Access Compliance Report

Public Rights-of-Way

Intersection ID: 10006563	Main Street: SHADE_VALLEY_RD	Cross Street: OAKHURST_COMMONS_DR	Location: NW
ADA ID: ADCAF6BE5542	Ramp Type: Directional1	Initial Pass/Fail: Fail	Overall Compliance: No
Severity Score: 37.5			
Codes/Mitigation Info/Possible Solution		Field Measurements/Component Compliance

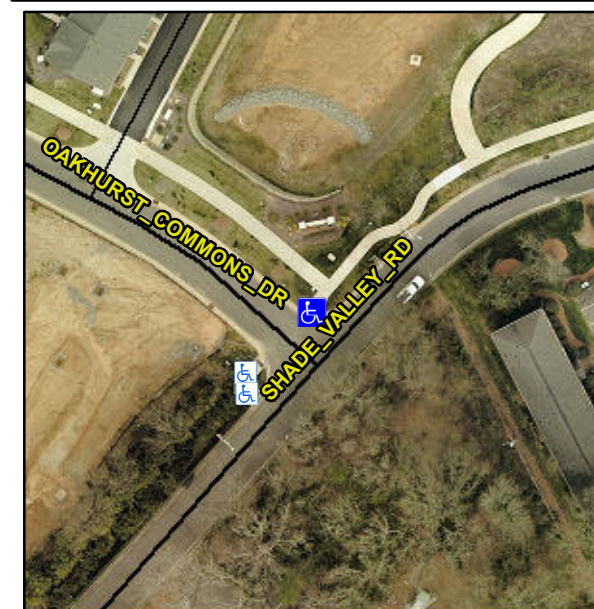
R304.2.2, R304.5.3

Compliance	Description	Data	Compliance	Description	Data
N/A	Ramp Length (in)	126.0	N/A	Grade Break?	N/A
Yes	Ramp Width (in)	64.0	N/A	Grade Break Slope (%)	0.0
No	Ramp Slope (%)	11.6	N/A	Grade Break XSlope (%)	0.0
No	Ramp XSlope (%)	9.4			
N/A	Flare Type LT	N/A	N/A	Flare Type RT	N/A
N/A	Flare Slope LT (%)	N/A	N/A	Flare Slope RT (%)	0.0
N/A	Flare Traversable LT?	N/A	N/A	Flare Traversable RT?	N/A
N/A	Landing Length (in)	0.0	N/A	DWS Provided?	N/A
N/A	Landing Width (in)	0.0	N/A	DWS Contrast?	N/A
N/A	Landing Slope (%)	0.0	N/A	DWS Length (in)	N/A
N/A	Landing X Slope (%)	0.0	N/A	DWS Full Width?	N/A
N/A	Landing Curb? (Y/N)	N/A	N/A	DWS Offset LT (in)	N/A
N/A	Shared Landing?	N/A	N/A	DWS Offset RT (in)	N/A
N/A	Gutter Ponding?	0.0	N/A	Gutter Slope (%)	N/A
N/A	Gutter Lip Ht (in)	2.0	N/A	Gutter X Slope (%)	N/A
N/A	Painted X Walk1?	No		Road Slope (%)	1.3
	X Walk 1 Direction	To SW		Road X Slope (%)	5.6
	X Walk 1 Width (in)	N/A		Clear Space?	N/A

Remove & Replace Entire Ramp.
